SUBJECT:- POWER ASSISTED STEERING UNIT.

MODELS AFFECTED.

SUBJECT:- P.A.S. ADJUSTER PLATE.

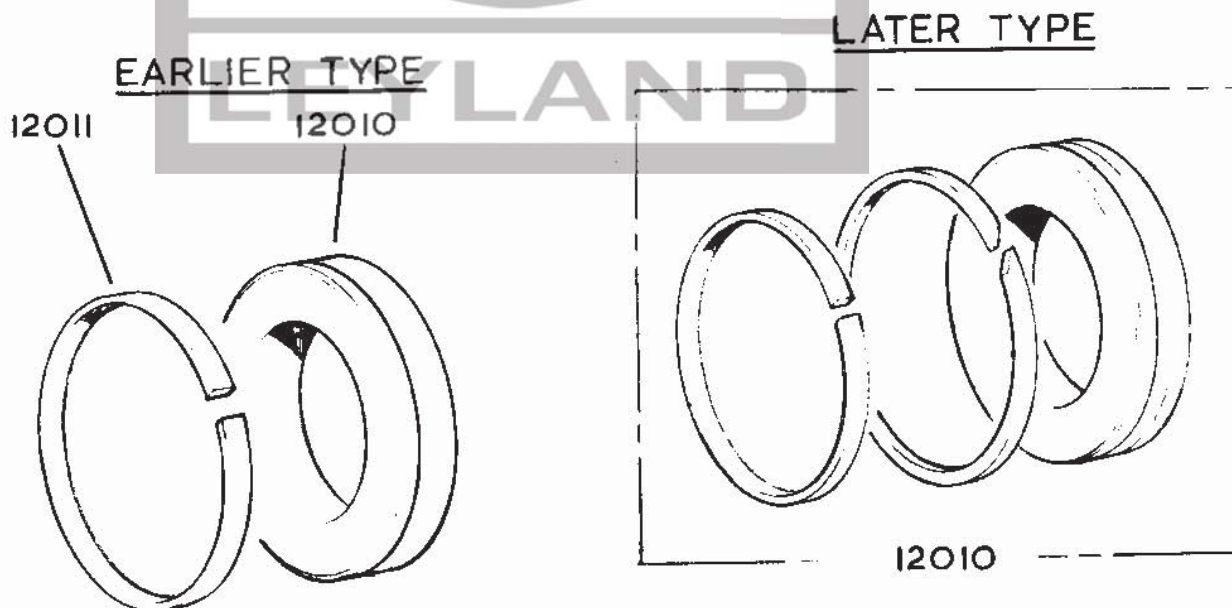
A revised Rack Piston Assembly is now being fitted to the above models.

The new Piston will have the same number (12010), but will be supplied as a complete assembly which will include one steel and one plastic ring.

The revised Piston/Rings Assembly is completely interchangeable with the previous Piston.

Piston Ring 12011 will no longer be supplied.
